Headlamp Washer Jet Cover Pivot Link –
Change Of Specification –
Service Action S940

MODEL 2002-03 MY
X-TYPE

VIN C00294-D29054

ILLUSTRATION 1

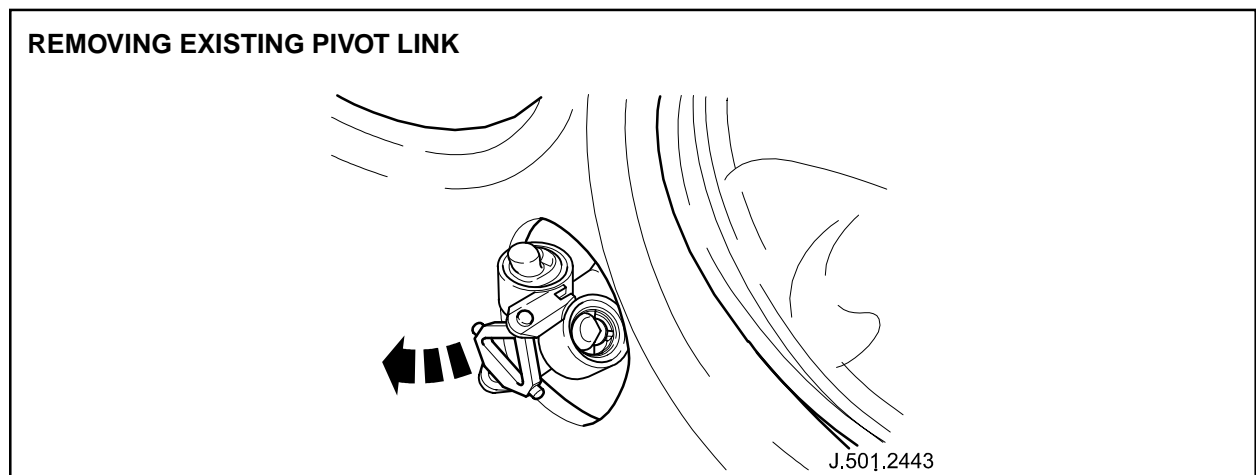
1. Grip headlamp power wash jet cover with fingers and slowly pull headlamp power wash jet out to its operating position.
2. Remove the cover of the headlamp power-wash jet from the link.
3. Remove the link from headlamp power-wash jet. (Illustration 1)

ILLUSTRATION 2

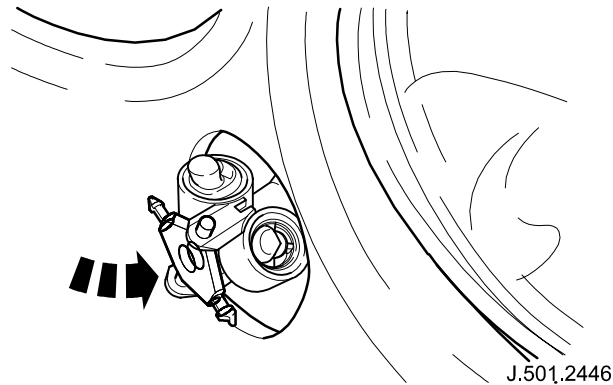
4. Install and seat new link to headlamp power-wash jet (Illustration 2).

Note: New link pegs are offset lowermost when installed for correct seating of cover to bumper.

ILLUSTRATION 3

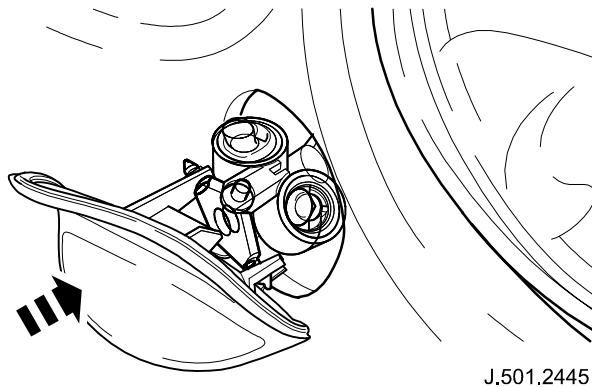
5. Install power wash jet cover to new link (Illustration 3).

Note: Power-wash jet covers are marked on the rear face left hand or right hand.
